**FEMA Levee Certification
Ventura County, California**

**Santa Clara River Levee (SCR-1)
Highway 101 to Saticoy**

**Evaluation Report
February 13, 2009**

Evaluation Report

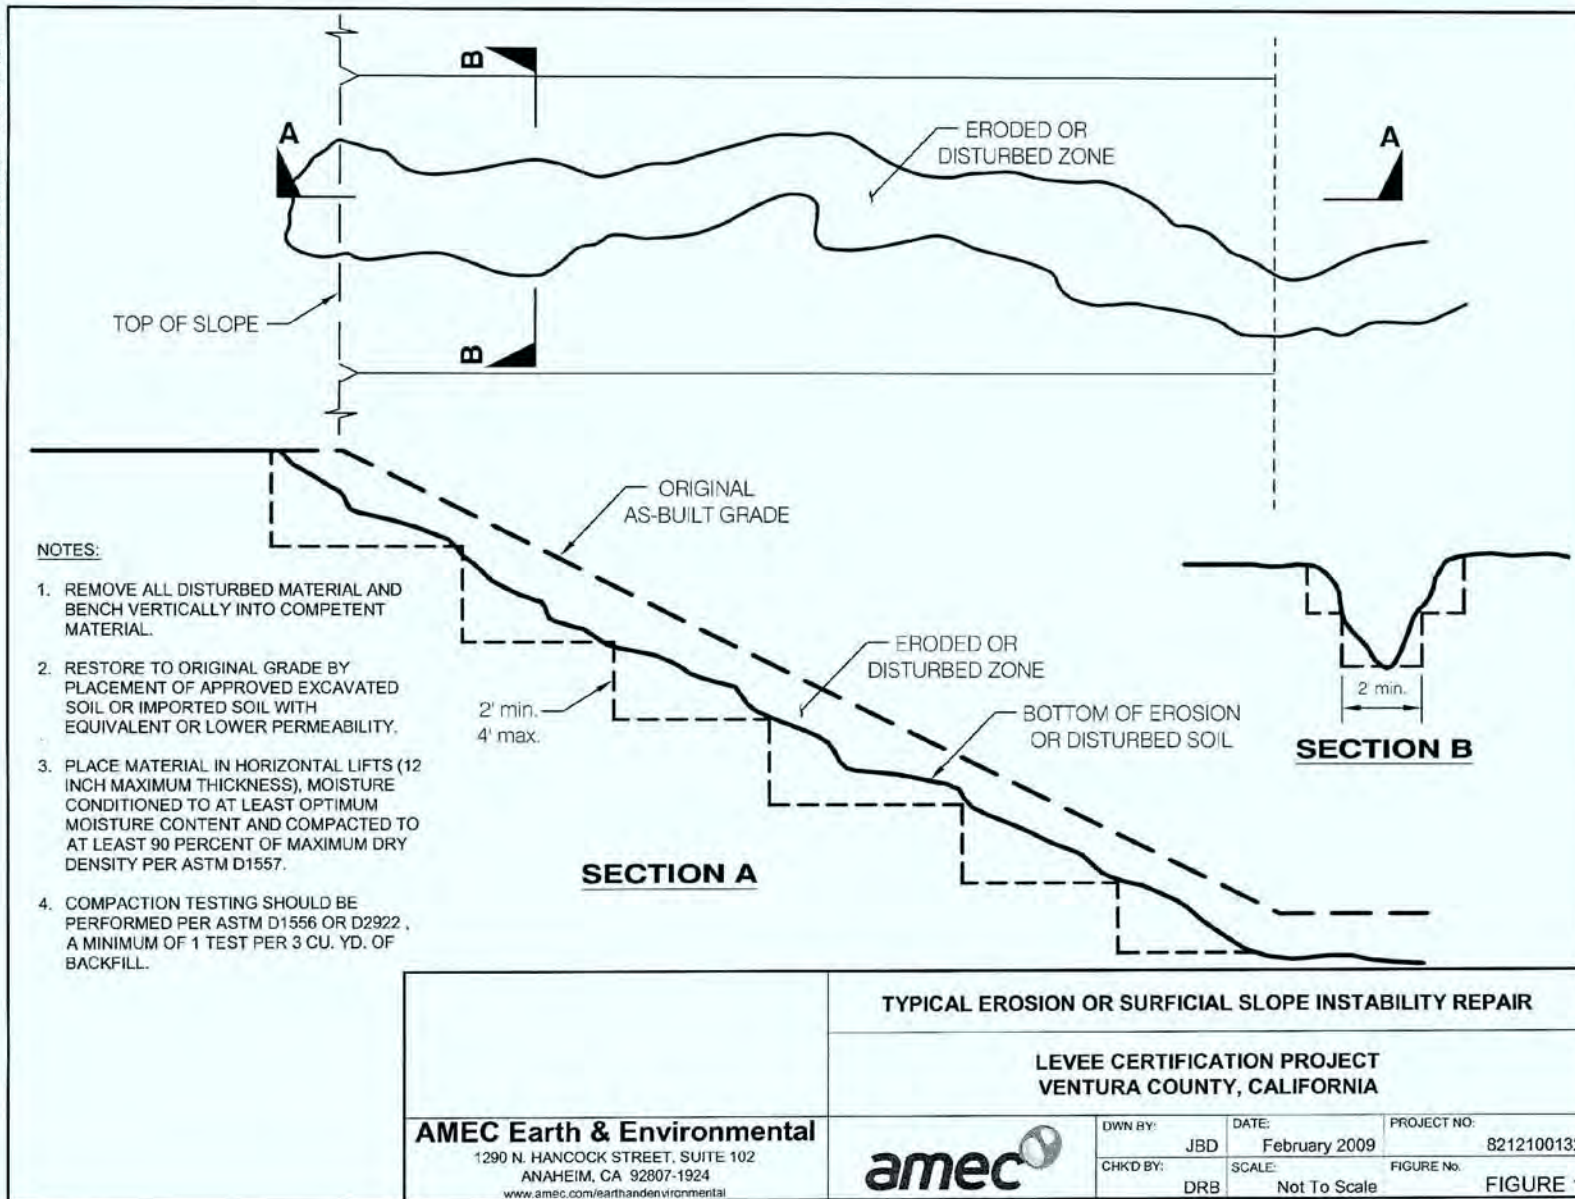
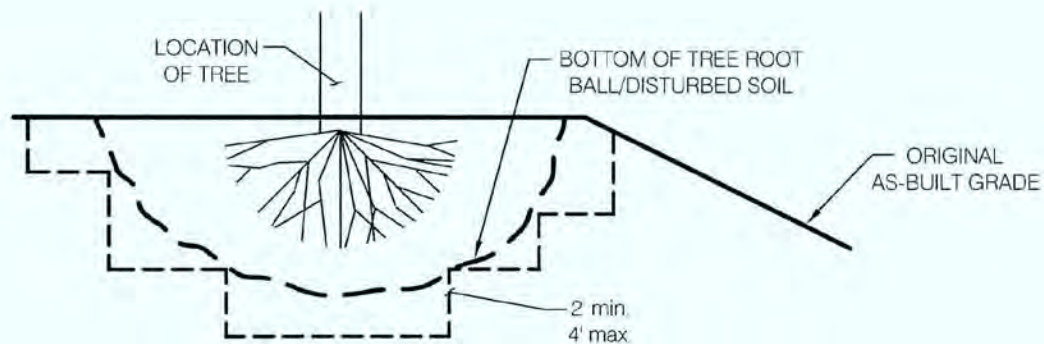
<p>4. Can Tetra Tech provide specs for compaction and grading requirements? Discuss major and minor repair examples.</p>	<p>Compaction requirements are detailed on the attached Figures 1 and 2. Major repair examples include any erosion feature that is deeper than 1 foot or that is greater than 2 feet wide. Major and minor animal burrows are discussed in item 1.</p>
<p>5. Can in-kind materials be used for backfill?</p>	<p>In-kind backfill would be materials free of organic or deleterious debris that has similar or lower permeability than the levee material. These materials could consist of excavated soil, imported soil, concrete, or slurry, and shall be evaluated by the testing and materials lab.</p>
<p>6. Discuss documentation/inspection requirements for verification of grading.</p>	<p>The requirements for verification of grading are discussed above.</p>

1. REMOVE ALL DISTURBED MATERIAL AND BENCH VERTICALLY INTO COMPETENT MATERIAL.
2. RESTORE TO ORIGINAL GRADE BY PLACEMENT OF APPROVED EXCAVATED SOIL OR IMPORTED SOIL WITH EQUIVALENT OR LOWER PERMEABILITY.
3. PLACE MATERIAL IN HORIZONTAL LIFTS (12 INCH MAXIMUM THICKNESS), MOISTURE CONDITIONED TO AT LEAST OPTIMUM MOISTURE CONTENT AND COMPACTED TO AT LEAST 90 PERCENT OF MAXIMUM DRY DENSITY PER ASTM D1557.
4. COMPACTION TESTING SHOULD BE PERFORMED PER ASTM D1556 OR D2922, A MINIMUM OF 1 TEST PER 3 CU. YD. OF BACKFILL.
